Airport Master Plan Update

Syracuse Hancock International Airport

RFQ Reference #: 2020-02

RFQ Addendum 2: Question & Answer Summary

SYR Property Map

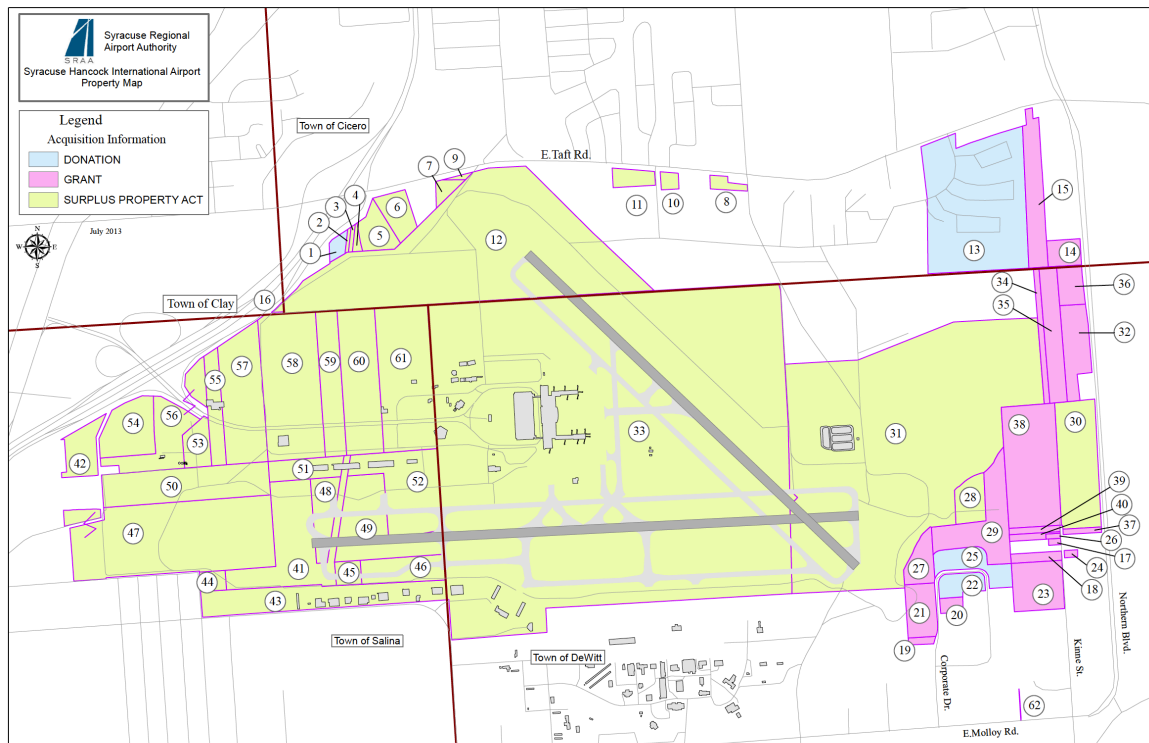
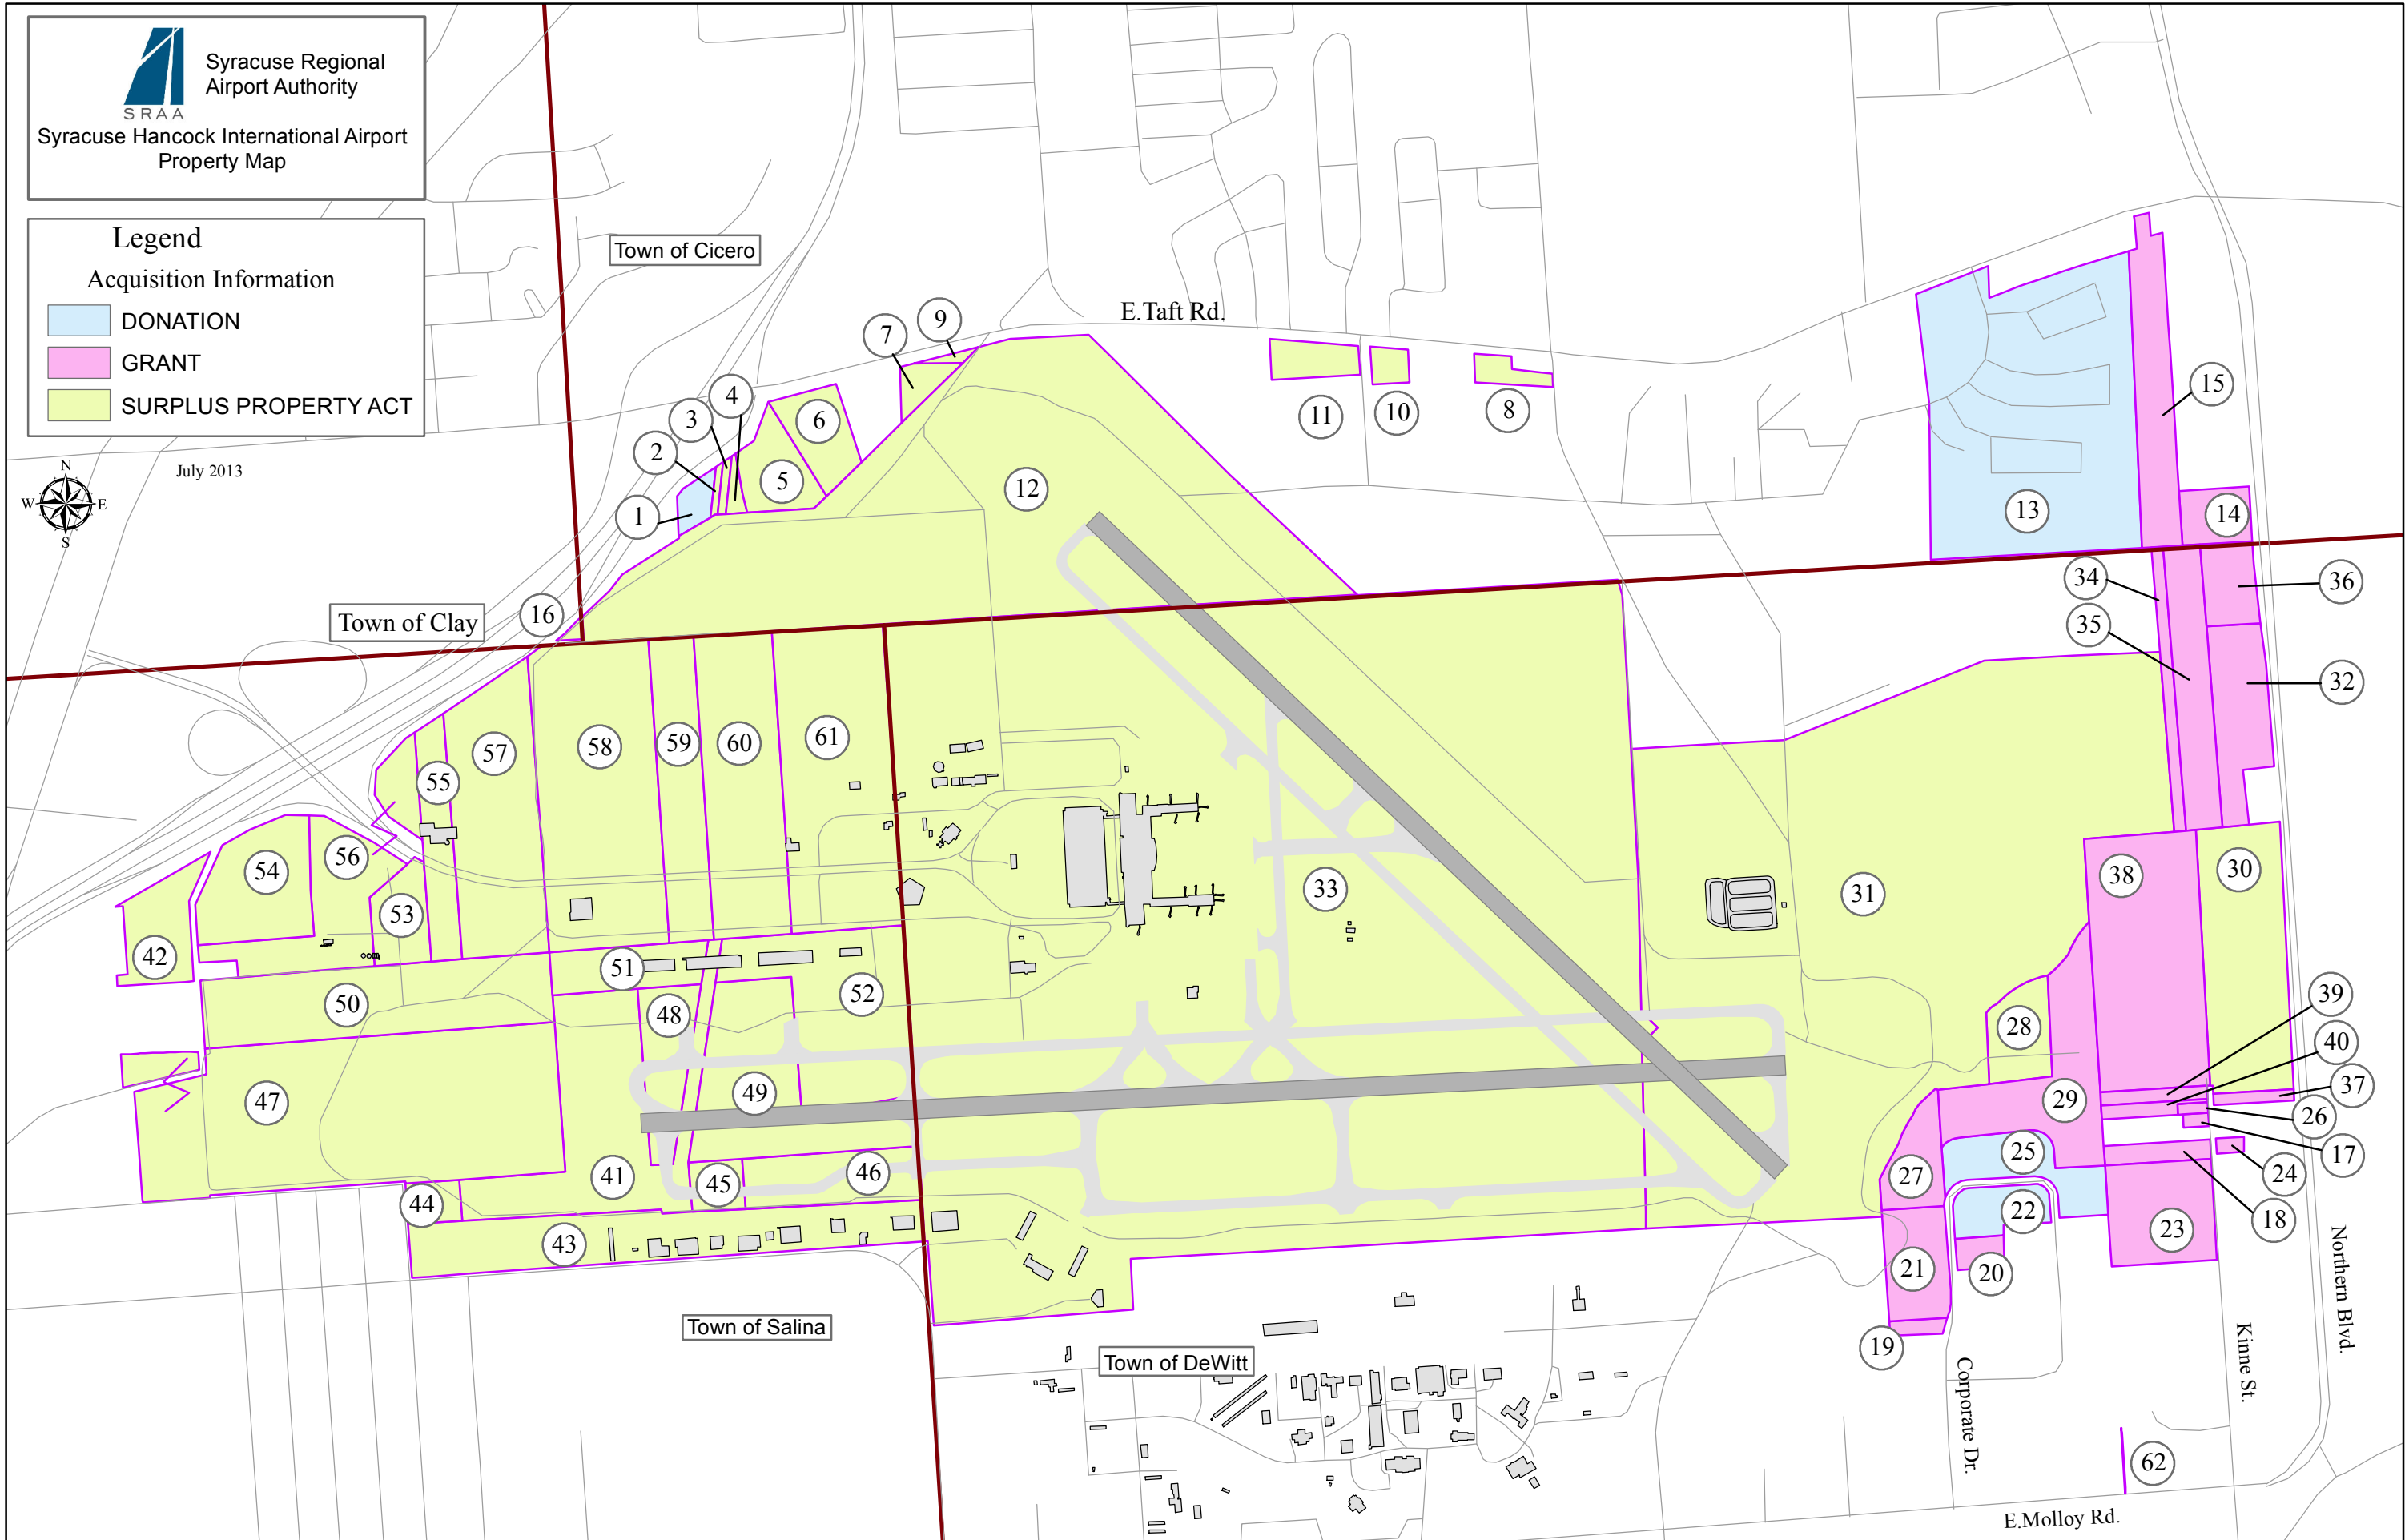
Has there been any property added to the Airport since the 2006 Master Plan?

There are no additional parcels that have been purchased since 2006. The Airport has bought and/or acquired properties over the last 13+ years. These properties are indicated on the ALP which includes the past revisions provided in the SharePoint files. The most recent properties are located along Kinne Street and called out on the ALP under revision 4 and 9; these parcels have been incorporated and shown within the Airport property boundaries indicated on this ALP. (See attached SYR Property Map.)
